BGT B Pit, Below-Grade Tank, or
Proposed Alternative Method Permit or Closure Plan Application

DENIED

1.
Operator: BP AMERICA PROD. CO. OGRID #: 778
Address: 1199 Main Ave., Suite 101, Durango, CO 81301
Facility or well name: FLORANCE AC 003
API Number: 3004509282 OCD Permit Number: _____
U/L or Qtr/Qtr M Section 22.0 Township 30.0N Range 09W County: San Juan County
Center of Proposed Design: Latitude 36.792392 Longitude -107.773571 NAD: 1927 1983
Surface Owner: Federal State Private Tribal Trust or Indian Allotment

SINGLE WALLED BGT

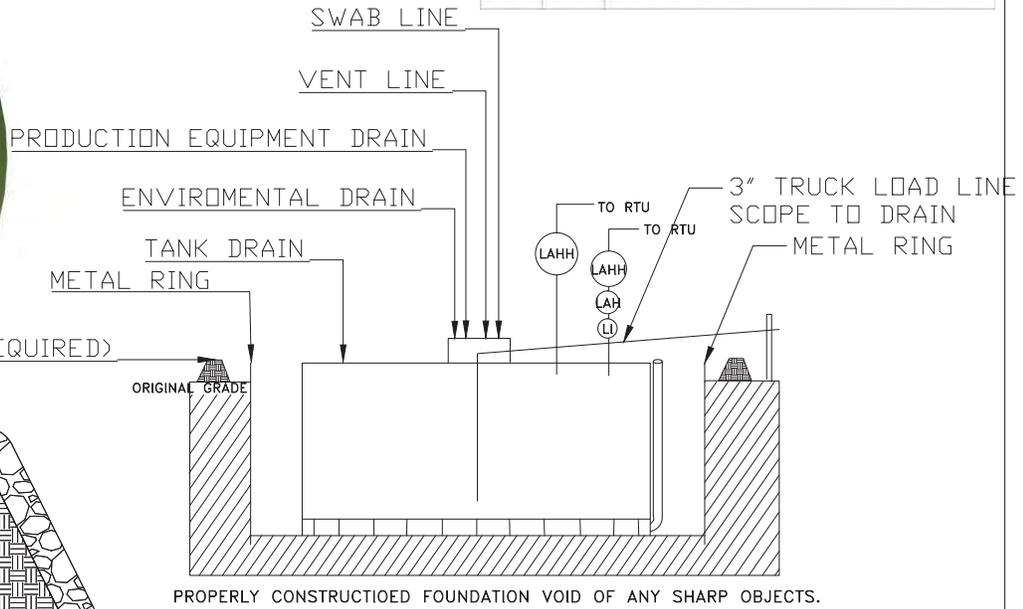
**Denied, BGT does not meet minimum Design Requirements per 19.15.17.11 NMAC
No liner Information/Design plan dosnt specifiy**
